Revision: Issue 01
Date: 09.04.2014

Meditex Industries Ltd (9253)

Client Summary Report

ACCORD
on Fire and Building Safety in Bangladesh

Uncertainty Regarding Inconsistent As-Built Drawings

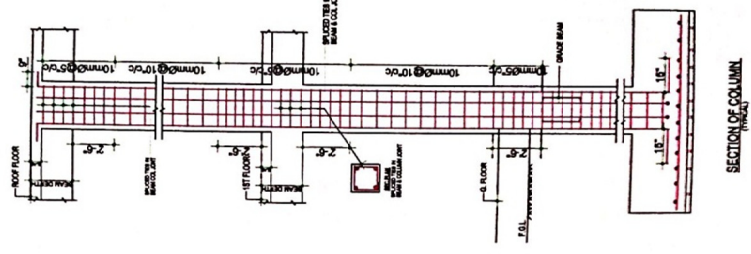
ITEM 1: (Priority 2) As-built drawings provided are in some instances inconsistent with building construction. It was not possible for the factory engineering staff to describe how the reinforcing shown on as-built drawings had been determined.

- Commission a detailed engineering assessment to ascertain the structural adequacy of as-built conditions as well as the quantities of existing reinforcement, sizes of structural members and building layout.

- Implement any works deemed necessary by the detailed engineering assessment.

Light Steel Framing at Rooftop Shed

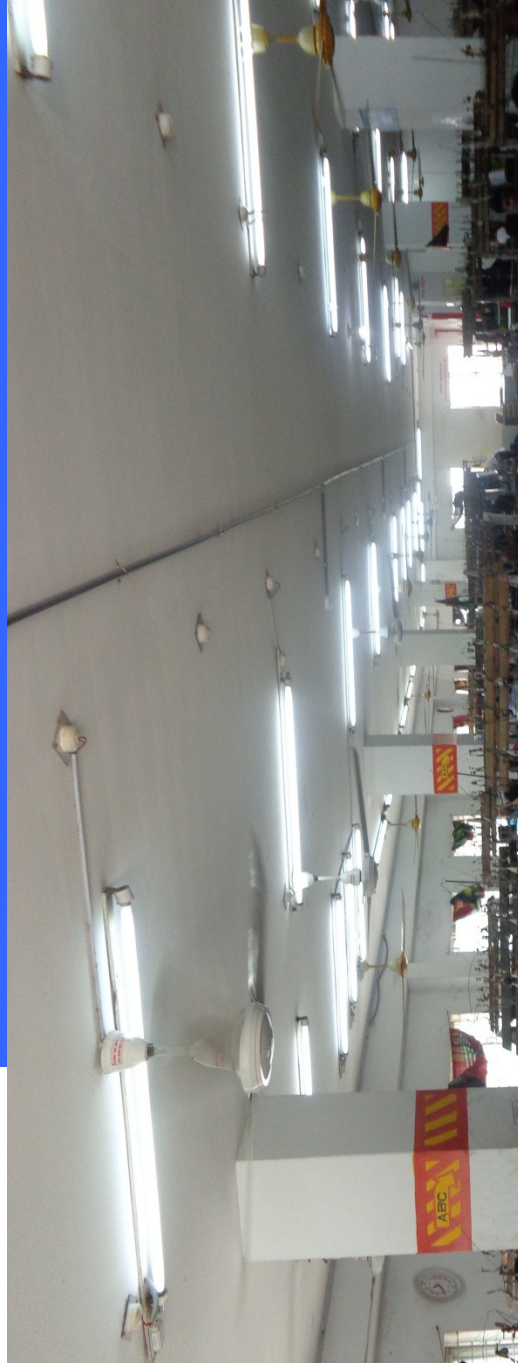
Exceedingly light steel sections were observed framing the shade over the rooftop prayer area.

ITEM 3: (Priority 2) The prayer room shade at the rooftop level was composed of very light steel framing.

- Remove rooftop prayer room shade or detailed engineering assessment to comment on adequacy of steel shade framing to resist wind loads.

- If shade is not removed, implement any recommendations made by the detailed engineering assessment

Lateral Restraint System

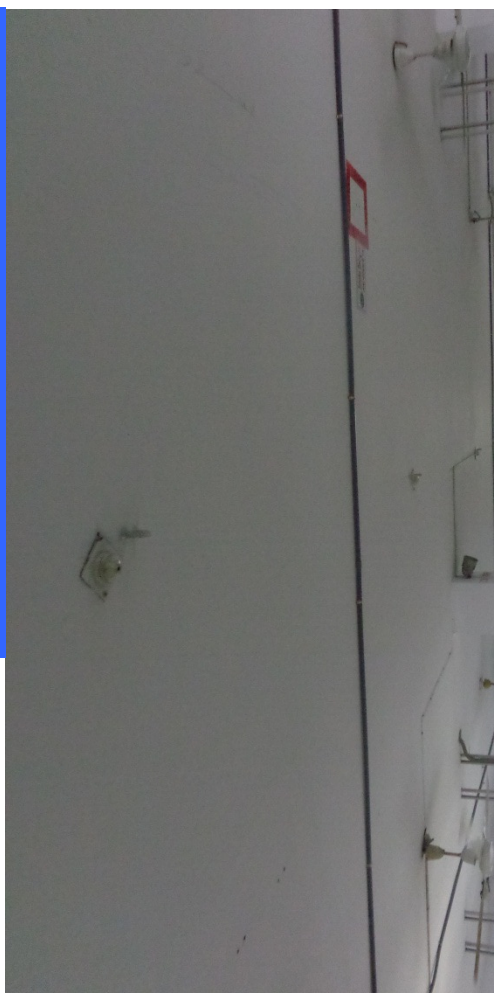
Within Phases 3 & 4 there are flat slab configurations above the 1st Floor slab level. Additionally there are no shear walls or braced frames present. This creates uncertainty regarding the lateral stability of these structures.

ITEM 4: (Priority 2) Phases 3 & 4 are lacking an apparent lateral restraint system.

- Detailed engineering assessment to determine adequacy of structure to resist seismic and wind loads.

- Implement any works deemed necessary by the detailed engineering assessment.
